Service Bulletin

SUBJECT: Service Update for Inventory and Customer Vehicles
Transfer Case Adapter Missing Lower Bolts
Expires with Base Warranty

MODELS: 2015 Chevrolet Colorado 4WD
2015 GMC Canyon 4WD
Equipped with 2.5L Engine (RPO LCV) and 6-Speed Automatic
Transmission (RPO MYB)

Subject: 15008 – Service Update Bulletin
Transfer Case Adapter Missing Lower Bolts

4135343

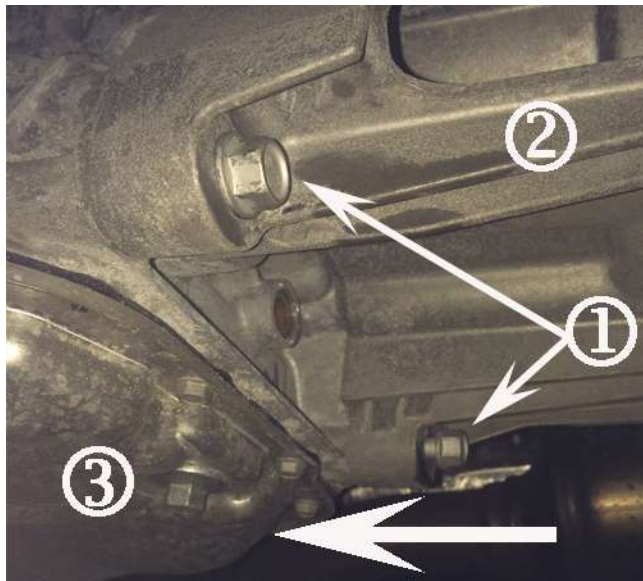
Note: Confined area calls for a short socket.

Note: The adapter is bolted to the transmission with six fasteners inside the adapter housing. Threading in the two lower external bolts may meet with some resistance. If needed, gradually thread bolts in/out before final torquing to ensure complete seating of fasteners.

2. Install the two transfer case adapter lower bolts (1) through the adapter (2) and into the transmission (3).
3. Torque the bolts to **58 Nm (43 lb-ft)**.
